Product hierarchy no. *				Part no.	SBU	Type / Description	Customer part no.
SBU	PG	PUG	Type				
02	007	001	0000002312	See list below	Connector	2573 Appliance Inlet C8	n/a

2 Type of change

Product Change Notification					2573 Change of marking		
owner	creation date	release date	released by	change order no	rev	page	D10-055-680
zeierjo	31.03.2021	31.03.2021	muehlema	2021025	B	1 of 2

Old product rating and approval	New product rating and approval
<p>Terminals in orientation A</p> <p>Front side</p>  <p>Back side</p> 	<p>Terminals in orientation A</p> <p>Front side</p>  <p>Back side</p>

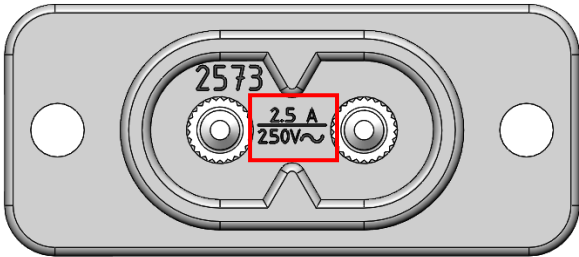
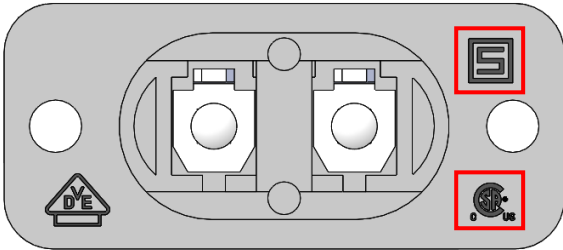
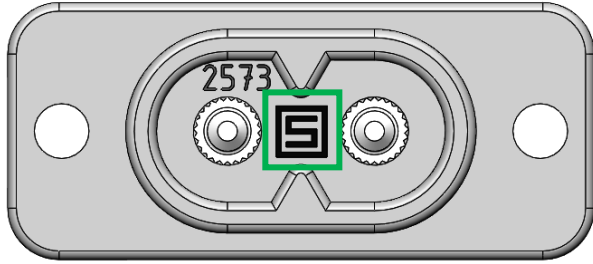
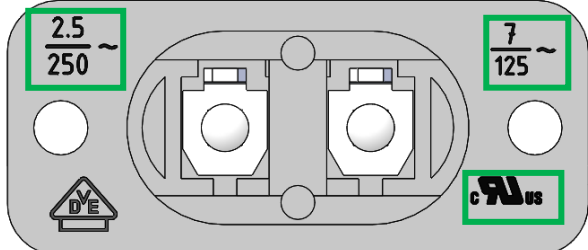
UL upgrade from UL 498 to UL 60320-1.

Marking for UL rating 7A/125V~ added. Marking for IEC rating 2.5A/250V~ updated. CSA / UR Approval Mark replaced by cURus.
